Current Zoning: B-1 (neighborhood business)  
Proposed Zoning: MUDD-O (mixed use development, optional) with three-year vested rights

Approximately 0.34 acres located at the southwest intersection of Seigle Avenue and Belmont Avenue, north of Harrill Street.

The petition proposes rezone a lot previously used as an auto car garage to allow the construction of a 9,000-square foot mixed-use building residential and nonresidential uses.

Staff recommends approval of this petition upon resolution of outstanding issues related to environment.

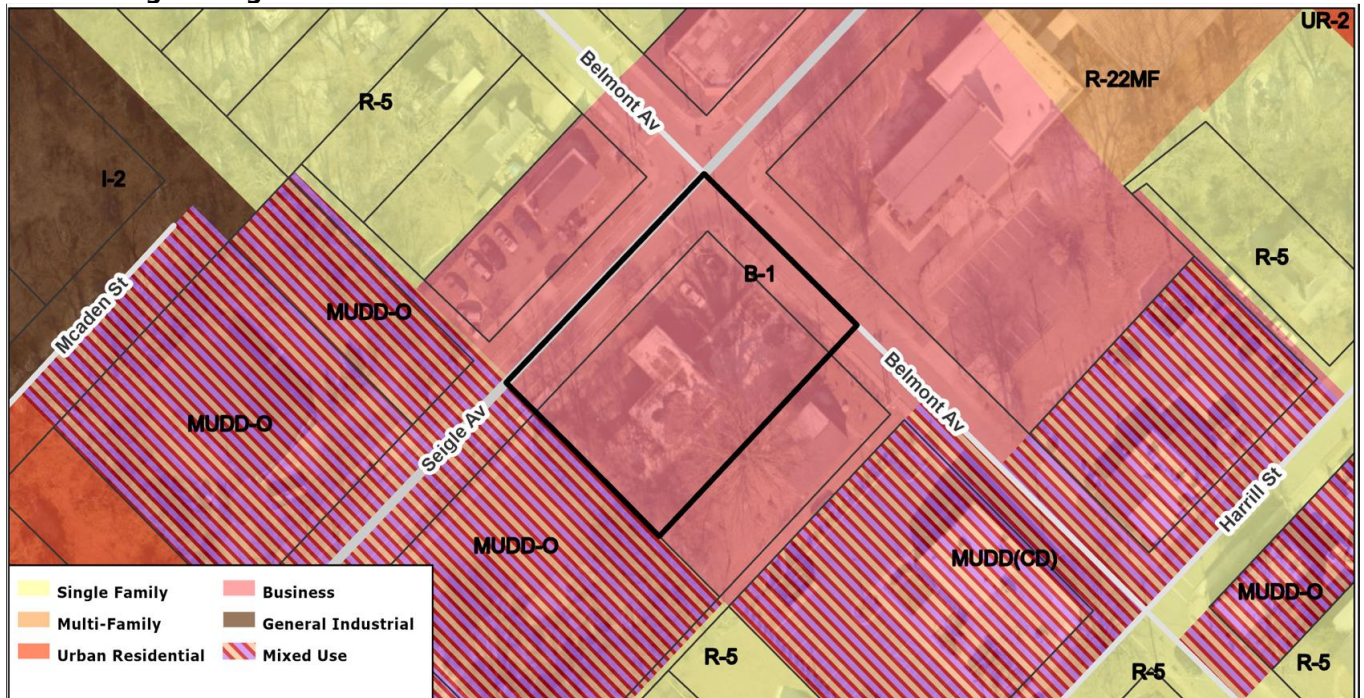
Existing curb and gutter can remain in existing location but label and dimension the future curb and gutter location from the centerline for each road on the site plan. Addressed

- ~~1. The site plan shall label and dimension the right of way from the road centerline. Site plan shows 25' to centerline but does not show the existing 50' from centerline. Label and dimension the existing 50' right of way from centerline of road.~~ Addressed

- ~~2. CDOT requests petitioner commit to 8' sidewalk and place Streets Map streetscape behind future curb location.~~ Addressed
- ~~3. Add a conditional note specifying "A Right of Way Encroachment Agreement is required for the installation of any non-standard item(s) (irrigation systems, decorative concrete pavement, brick pavers, etc.) within a proposed/existing City-maintained street right of way by a private individual, group, business, or homeowner's/business association. An encroachment agreement must be approved by CDOT prior to construction/installation. Contact CDOT for additional information concerning cost, submittal, and liability insurance coverage requirements."~~ Addressed

- ~~4. Add a conditional note specifying "the Petitioner shall dedicate and convey in fee simple all rights-of-way to the City before the site's first building certificate of occupancy is issued. CDOT requests rights-of-way set at 2' behind back of sidewalk where feasible."~~ Addressed

- ~~5. Petitioner should revise the site plan and conditional notes to show sidewalk utility easement on plans behind proposed sidewalk.~~ Addressed

- ~~6. Petitioner should revise the site plan and conditional notes to show 10x10 triangles behind the sidewalk.~~ **Addressed**

7. Review urban tree requirements. While the 10' no build zone can be counted towards tree save there must still be a minimum of 10' of replanted tree save. (20' total width) Trees cannot be planted within 10' of a structure/retaining wall. Utilities such as transformers are not permitted within trees save or amenitized tree save. **Petitioner response:** Petitioner has reconfigured preliminary off-street parking layout to accommodate 10' distance & 10' width requirements. Potential transformer locations have been moved outside of amenitized tree save (See Site Plan on RZP-01, Rev 2). **Update:** Per discussion, the best option for tree save at this point will be provided per the ordinance and removed "potential tree save" designation for areas that we not sure would even qualify as tree save and review that during development plan review.

8. Trees outside of the property line cannot count towards any requirements. Trees must be completely on the property to count towards requirements. **Petitioner Response:** Petitioner commits to protecting the five "property line trees" on southern property line. (See Note 2D, RZP-01 Site Plan, Rev 2). Petitioner is open to amending the wording of this Optional Provision to suit Urban Forestry, if desired. Note: as provided to Henry Kunzig via 4-17-23 email, center measurement of 12" oak is completely on property at dbh. Updated Tree Survey uploaded to ACCELA. Petitioner is willing to reduce protection to just that tree, if desired. **Update:** While trees on the property line can be protected, trees not completely located on the property cannot be counted towards meeting tree save requirements.

- ~~9. Please confirm if residential is proposed as it is not specified under proposed uses.~~ **Addressed**
- ~~10. Under proposed list of permitted uses, please modify Type EDEE Types 1 and 2 to note subject to ordinance requirements.~~ **Addressed**
- ~~11. Under proposed list of permitted uses, please modify breweries to note subject to ordinance requirements.~~ **Addressed**
- ~~12. Include minimum % brick required on ground floor.~~ **Addressed**
- ~~13. Include minimum area for public open space required.~~ **Addressed**
- ~~14. The precedent imagery is showing a structure constructed with brick. Recommend brick being used as a primary building material on the first floor.~~ **Addressed**
